SIVAT: TELEPERM XS™
Simulation Validation Test Tool

ANP-10303NP-A
Revision 1

SUBJECT: FINAL SAFETY EVALUATION FOR AREVA NP, INC. (AREVA) ANP-10303P,
REVISION 1, "SIVAT: TELEPERM XS™ SIMULATION VALIDATION TEST
TOOL TOPICAL REPORT [TR]" (TAC NO. ME1503)

Figure 3-2 - SIVAT in the Application Software Development Process

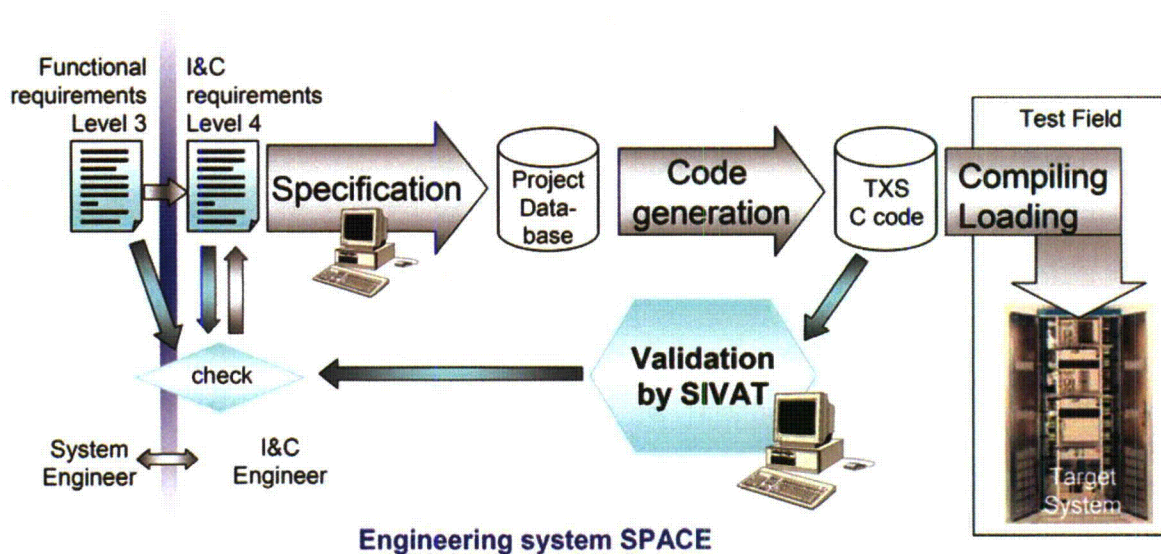
22. Figure 3-2 depicts a process labeled "Formal Verification" which apparently compares or verifies the generated C-Code against the Project Database. Two routines are referenced in this figure: "rediff" and "cmp_code." The definition of "rediff" in Section 2, however, states that "rediff" compares redundancies against each other and not code against the project database as is depicted in the figure. In addition, the definition of "cmp_code" provided in Section 2 does not explain how this tool is used to perform "Formal Verification." Please provide additional information on the use of the software tools "rediff" and "cmp_code" and explain how and when these tools are used to perform "Formal Validation" of safety related application software.

RAI 22 Question: Figure 3-2 depicts a process labeled "Formal Verification" which apparently compares or verifies the generated C-Code against the Project Database. Two routines are referenced in this figure; "rediff", and "cmp_code". The definition of "rediff" in Section 2, however, states that "rediff" compares redundancies against each other and not code against the project database as is depicted in the figure. In addition the definition of "cmp_code" provided in Section 2 does not explain how this tool is used to perform "Formal Verification". Please provide additional information on the use of the software tools "rediff" and "cmp_code" and explain how and when these tools are used to perform "Formal Validation" of safety related application software.

AREVA NP Response to RAI 22: The development of the TELEPERM XS Application Software is described in the TELEPERM XS Software Program Manual Topical Report. Figures 3-2 and 3-13 will be revised to remove the extraneous information in Revision 1 of the SIVAT Topical Report.

Figure 3-13 - ERBUS TELEPERM XS Concept

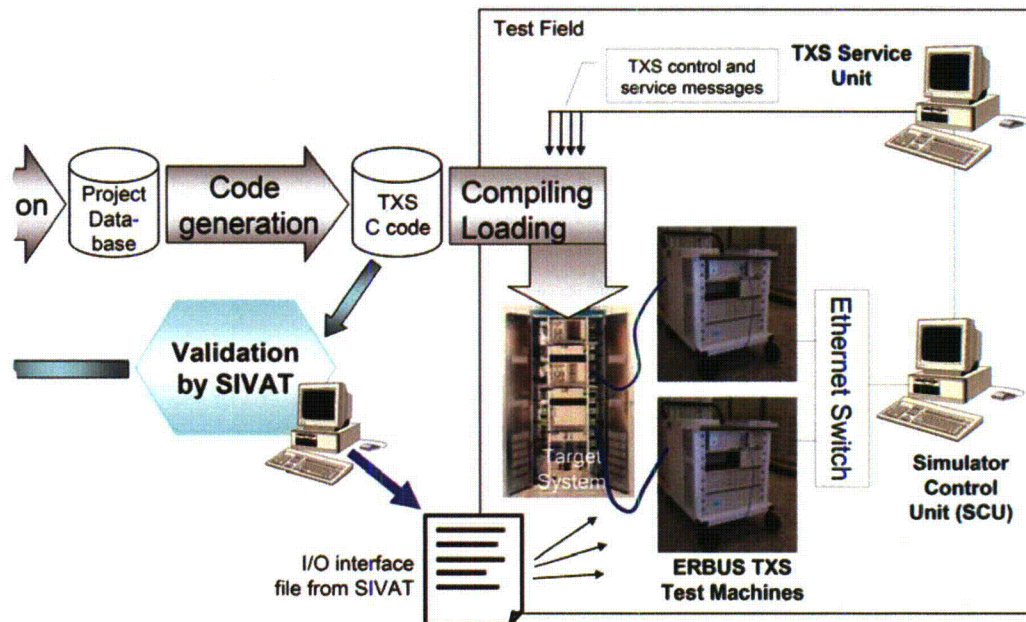
ERBUS testing is described as testing that is performed following the manufacture of the cabinet in the test field. Figure 3-13 of the SIVAT TR also illustrates ERBUS testing as testing that is performed independently from the use of SIVAT. This description of the ERBUS testing process is considered by the NRC staff to be informative. Though the NRC staff recognizes

13. Section 3.7 of the TR describes Simulation in the Test Field using ERBUS¹. ERBUS testing is described as testing that is performed following the manufacture of the cabinet in the test field. Figure 3-13 also illustrates ERBUS testing as testing that is performed independently from the use of Validation by SIVAT. Please explain the relevance of ERBUS in relation to the Validation Testing activities associated with SIVAT. This section appears to be informative in nature and not necessarily relevant to the qualification of SIVAT as a Verification and Validation (V&V) tool.

RAI 13 Question: Section 3.7 of the TR describes Simulation in the Test Field using ERBUS¹. ERBUS testing is described as testing that is performed following the manufacture of the cabinet in the test field. Figure 3-13 also illustrates ERBUS testing as testing that is performed independently from the use of Validation by SIVAT. Please explain the relevance of ERBUS in relation to the Validation Testing activities associated with SIVAT. This section appears to be informative in nature and not necessarily relevant to the qualification of SIVAT as a Verification and Validation (V&V) tool.

AREVA stated that "The description of ERBUS was included for completeness, since the same simulator control system that is used for SIVAT also runs on the Simulator Control Unit used in the test field." Refer to RAI questions 13 and 14 (Reference 4) for additional information regarding the use of ERBUS.
